Ref: Burner Inspection Report

Coal Burner Condition and Estimated Remaining Life Evaluation

Final Report

Intermountain Generating Station

Creep Strength vs. Temp. for AISI 304 SST

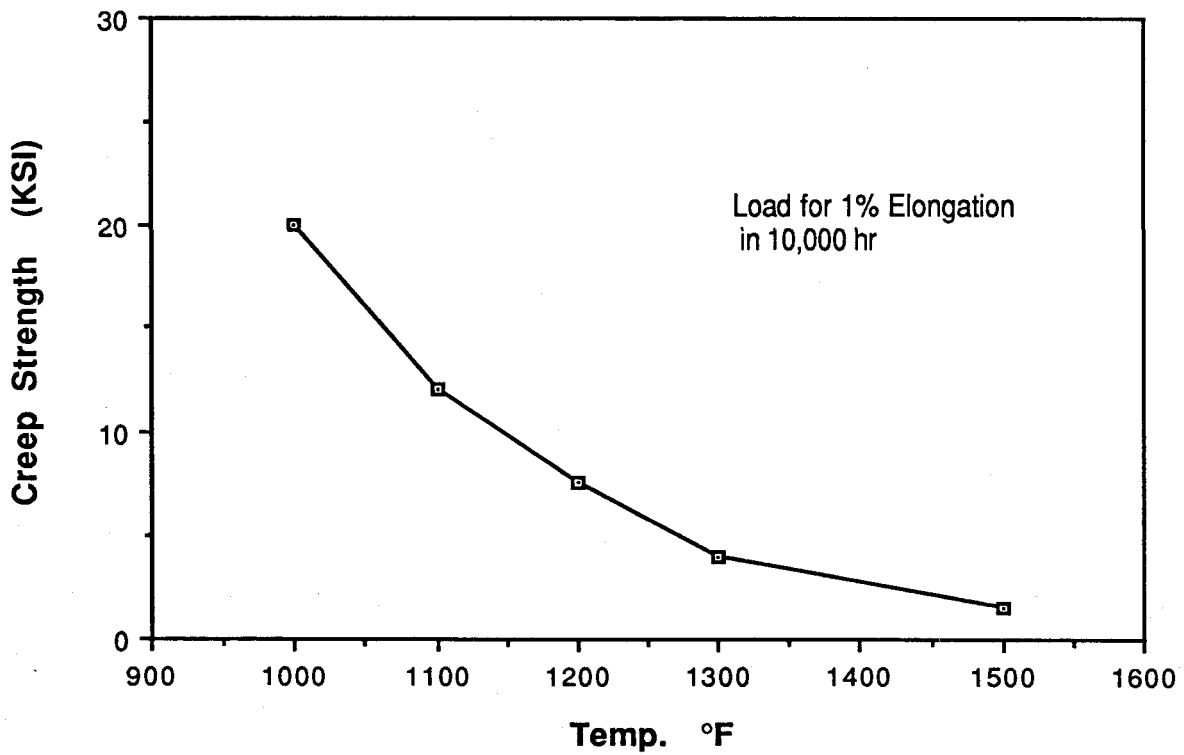
What is the creep strength to life (years) relationship?

BURNER ALTERNATIVES - Summary

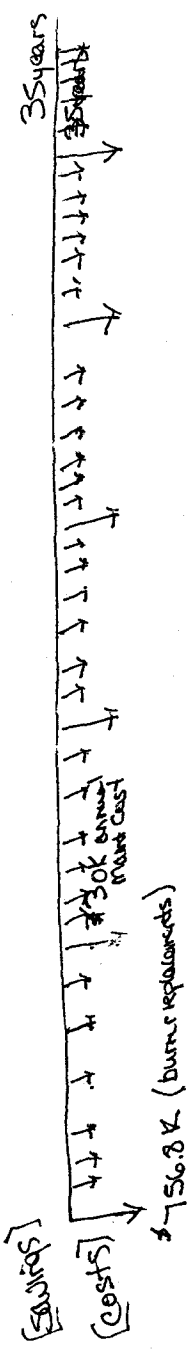
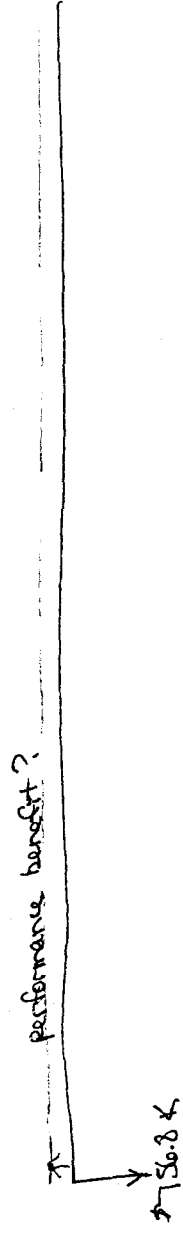
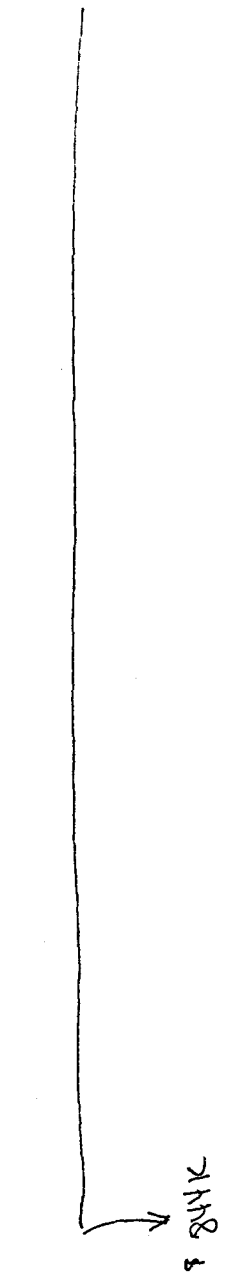
evaluate present values for each alternative
 35 year unit life / burner life 20-30 years 5-7 replacements
 calculate for both 1 unit / 2 units

Alternative 1
 Current mode of operation
 PV = unit ? 105\$
 2 units ?

Alternative 2
 3 pulveriser mode of operation
 PV = unit ?
 2 units ?

Alternative 3
 Increase cooling air requirement
 PV = unit ?
 2 units ?

Alternative 4
 Redesign burner
 PV = unit ?
 2 units ?
